## MOD5 SSD7348

### Response to Council submission on MOD5 - SSD7348, dated 9 September 2020

LGA: PENRITH  
Locality: KEMPS CREEK  
Reduction Ratio 1: 2000  
Lengths are in metres.

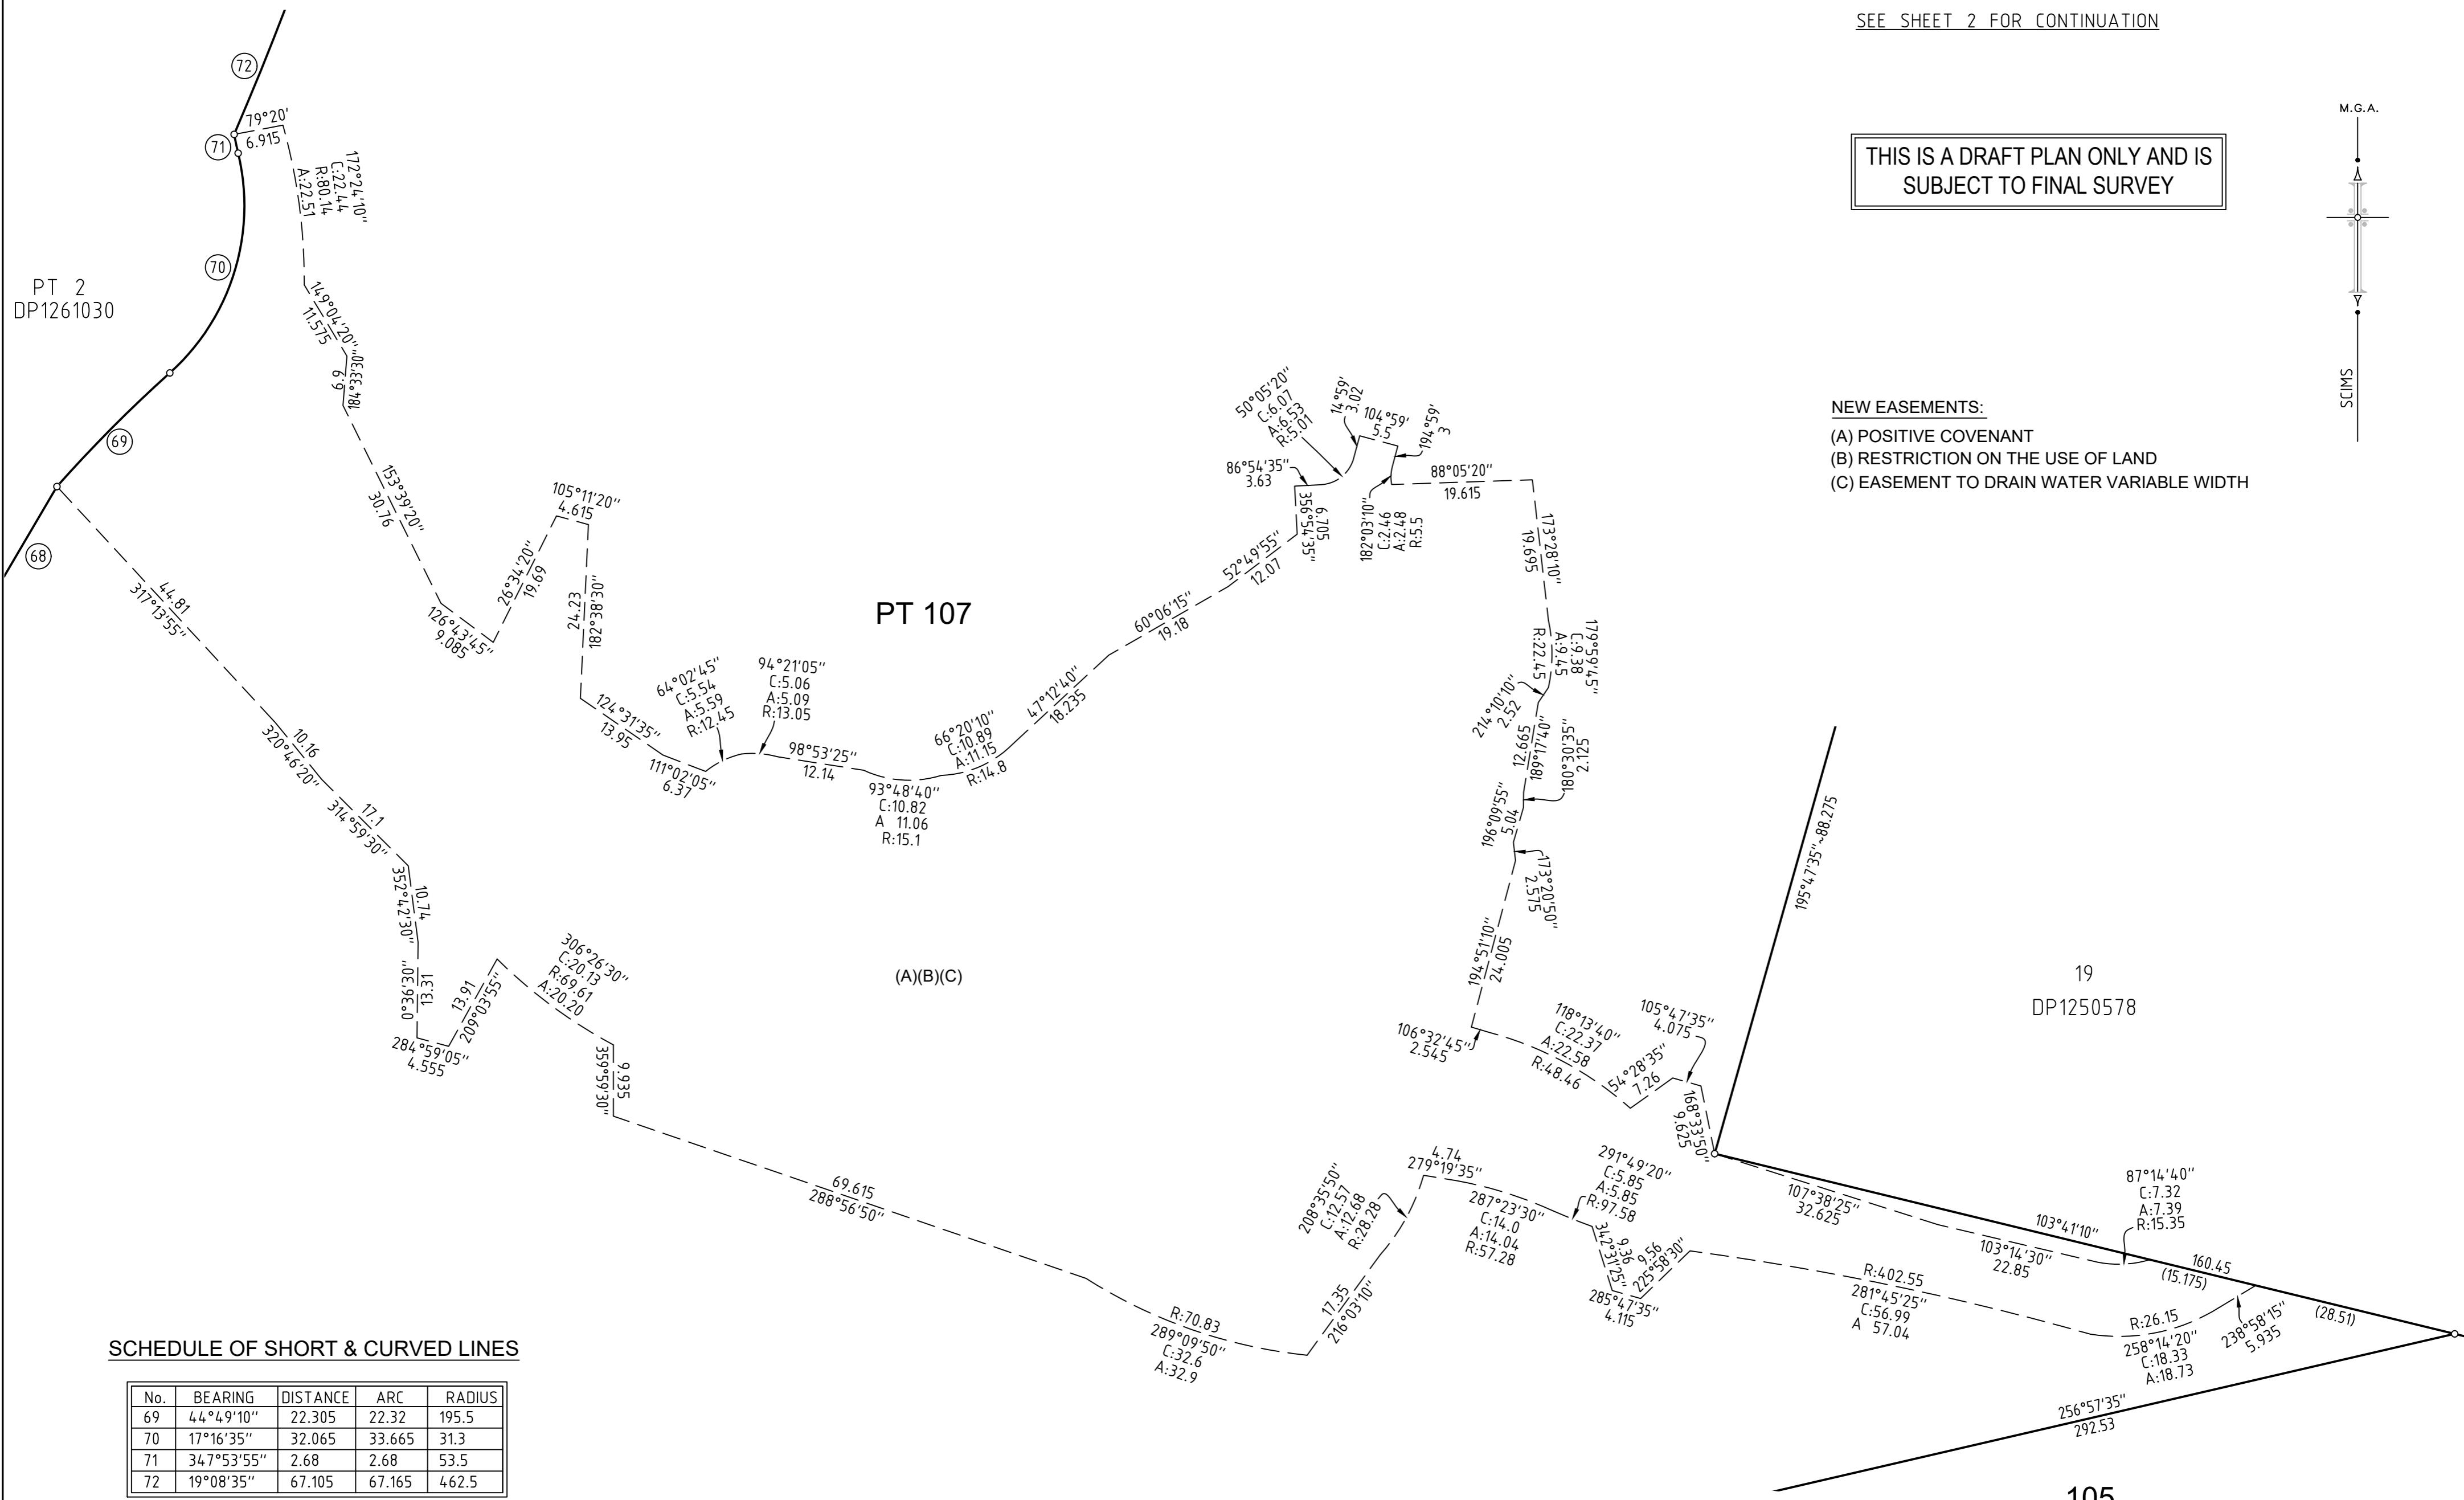
Correspondence has been recently received from TFNSW (dated 10 August 2020) that confirms that the width of the proposed southern link road allotment (proposed lot 105) is insufficient and cannot accommodate the necessary lanes required.	<ul style="list-style-type: none"><li>Goodman have responded to TrfNSW's request to increase the width of the Southern Link Road to 36.6m. Updated subdivision plans can be found within <b>Annexure B</b>.</li><li>TrfNSW has since confirmed acceptance of the subdivision plans. Refer to <b>Annexure A</b>.</li></ul>
The plans as submitted with that application have sought to widen the road reserve width beyond what was suggested in the above SSD determination, and TFNSW have now advised of further changes that are required to the proposed plans of subdivision to further widen proposed lot 105 (link road lot) to accommodate the link road intersection design requirements.	<ul style="list-style-type: none"><li>As above. The updated width of the road reserve, as requested by TfNSW, has been included in both the SSD7348 MOD5 and DA19.0575 plans.</li></ul>

As discussed, land required for Southern Link Road (SLR) does not align with the land identified in the proposed subdivision plan. The land requirement for the SLR would be a combination of purple and red line boundaries shown on the attached plan. The proposed subdivision is generally along the purple line boundary.

Please submit updated subdivision plans showing area bounded by the red line to Council for referral to TfNSW. Identification of this land on the subdivision plan is required to ensure that structures, buildings or utilities are not allowed within this land.

TfNSW Comment	Goodman Response
<b>Planning, Engineering and Landscaping Matters</b>	
The proposed Modification No. 5 to SSD Determination No. 7348 seeks to respond to an unapproved subdivision arrangement that is the subject of a current development application with Council which as yet, is not supportable by Transport for NSW (TFNSW). The assessment and determination of this separate subdivision application is dependant on endorsement of the proposed lot creation and resulting road reserve widths which have not been accepted by TFNSW.	<ul style="list-style-type: none"><li>Subdivision approval has been granted by DPIE as part of the initial SSD 7348 consent and SSD 7348 MOD 2 consent;</li><li>Goodman had lodged DA19.0575 with Council on 23 August 2019 which was prior to determination of SSD 7348 MOD 2;</li><li>Both subdivision plans have now been endorsed by TrfNSW (per <b>Annexure A</b>), albeit with proposed conditions. The latest subdivision plans that accommodate TrfNSW's comments can be found in <b>Annexure B</b>.</li></ul>

We refer to the below email, and our call this morning and confirm our discussions that TrfNSW are satisfied with the updates Goodman have made to the subdivision plan that reflect the 36.6m Southern Link Road (SLR) corridor.

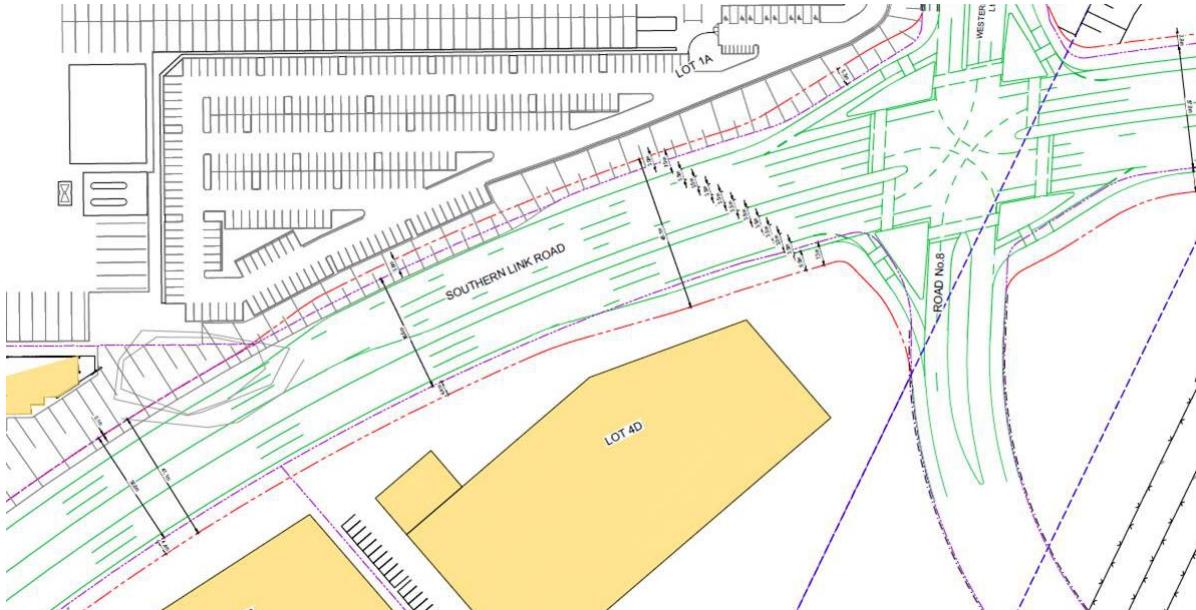
We don't believe it is necessary to further burden the land by way of an easement to ensure authorities or Goodman cannot construct structures or services between the purple and red area.

- Once TrfNSW have approval to proceed with a preferred design, they may approach Goodman to acquire the land for the Southern Link Road;
- As the subject subdivision and intersection width only relates to the extract below, being Precinct 1A, there is ample land within the setback and car parking area (which can be reconfigured at the time) to accommodate TrfNSW's request further down the track once TrfNSW know what they are actually constructing.
